Date:	November 6, 2007	Bulletin Number:	07D-184
To:	All Distributors	Category:	Service
From:	Jeff Spitzer, Product Service	Line(s):	02

**Subject: Wheel Hub Changes (Gen II vs. Gen III)**

Please see below for examples of the two designs:

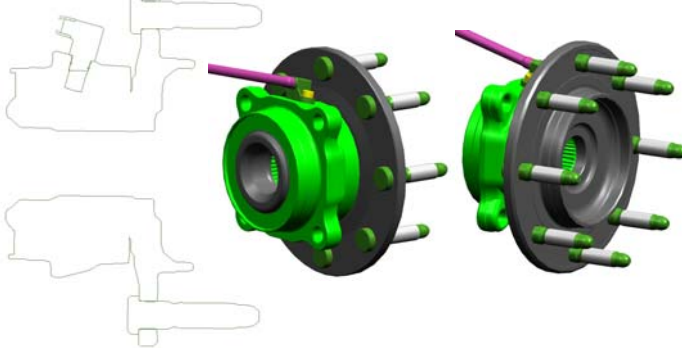
When replacing an older Gen II design 4x2 hub with a new 4x2/4x4 common Gen III hub, we want to assure technicians that it is OK to have a bearing with splines on it for a 4x2 application that previously didn't. However, the older Gen II design 4x4 hubs should NOT be used on a 4x2 vehicle. The Gen II 4x4 hub relies on the tension of the half shaft joint to hold everything together. The roll form feature on the IB (inboard) side of the new 4x2/4x4 Gen III hub eliminates this concern.

**Note: Only the new part numbers referenced in this bulletin are interchangeable between the 4x2 and 4x4 applications with the exception of FW240 (15719007). Under no circumstances should any other 4x4 hub be used in a 4x2 application.**
